# Access Compliance Report

## Public Rights-of-Way

### (Curb Ramps)

Intersection ID: 18709	Main Street: FOX_RUN_DR	Cross Street: MONROE_RD	Location: NE
ADA ID: 8EAF0E88ADD	Ramp Type: Perpendicular Diagonal	Initial Pass/Fail: Fail	Overall Compliance: No
		Severity Score: 50

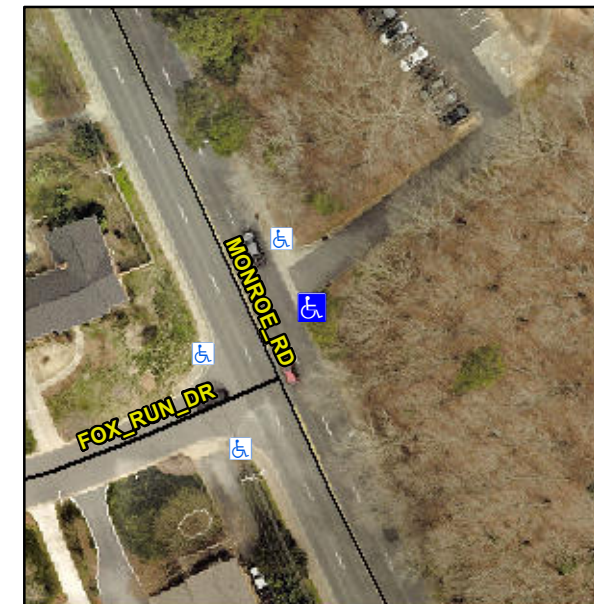
**Not Found, R304.2.2, R304.5.3**

Compliance	Description	Data	Compliance	Description	Data
N/A	Ramp Length (in)	60.0	No	Ramp Slope (%)	12.8
Yes	Ramp Width (in)	48.0	No	Ramp XSlope (%)	10.1
N/A	Flare Type LT	N/A	N/A	Flare Type RT	N/A
N/A	Flare Slope LT (%)	N/A	N/A	Flare Slope RT (%)	N/A
N/A	Flare Traversable LT?	N/A	N/A	Flare Traversable RT?	N/A
N/A	Landing Length (in)	N/A	N/A	DWS Provided?	N/A
N/A	Landing Width (in)	N/A	N/A	DWS Contrast?	N/A
N/A	Landing Slope (%)	N/A	N/A	DWS Length (in)	N/A
N/A	Landing X Slope (%)	N/A	N/A	DWS Full Width?	N/A
N/A	Landing Curb? (Y/N)	N/A	N/A	DWS Offset (in)	N/A
N/A	Shared Landing?	N/A			
N/A	Gutter Ponding?	N/A	N/A	Gutter Slope (%)	N/A
N/A	Gutter Lip Ht (in)	N/A	N/A	Gutter X Slope (%)	N/A
N/A	Painted X Walk1?	No	N/A	Painted X Walk2?	No
	X Walk 1 Direction	To N		X Walk 2 Direction	To W
N/A	X Walk 1 Width (in)	N/A	N/A	X Walk 2 Width (in)	N/A
	X Walk 1 Slope (%)	3.3		X Walk 2 Slope (%)	2.4
	X Walk 1 X Slope (%)	11.0		X Walk 2 X Slope (%)	2.8

**Remove & Replace Curb Ramp With Two New Directional Ramps or Equivalent.**
